Access Compliance Report

Public Rights-of-Way

(Curb Ramps)

Intersection ID: 12935	Main Street: GAYNELLE_DR	Cross Street: HICKORY_GROVE_RD	Location: NE
ADA ID: 491E9D14B1FB	Ramp Type: PerpDiag	Initial Pass/Fail: Fail	Overall Compliance: No
		Severity Score: 12.5

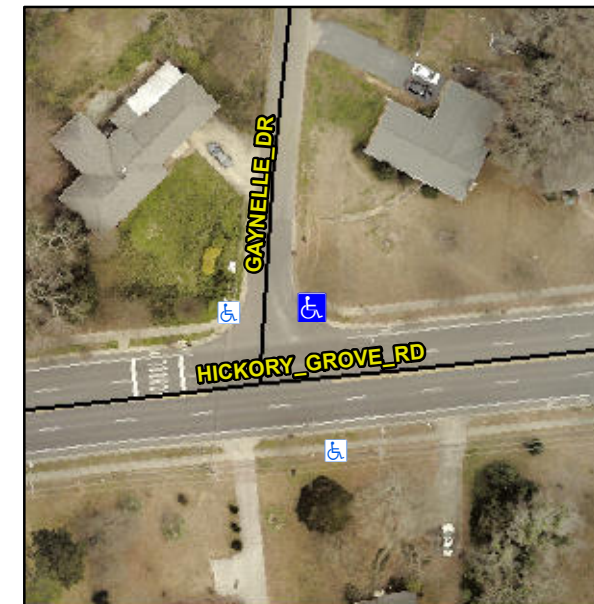
Not Found, R304.2.2

Remove & Replace Curb Ramp With Two New Directional Ramps or Equivalent.
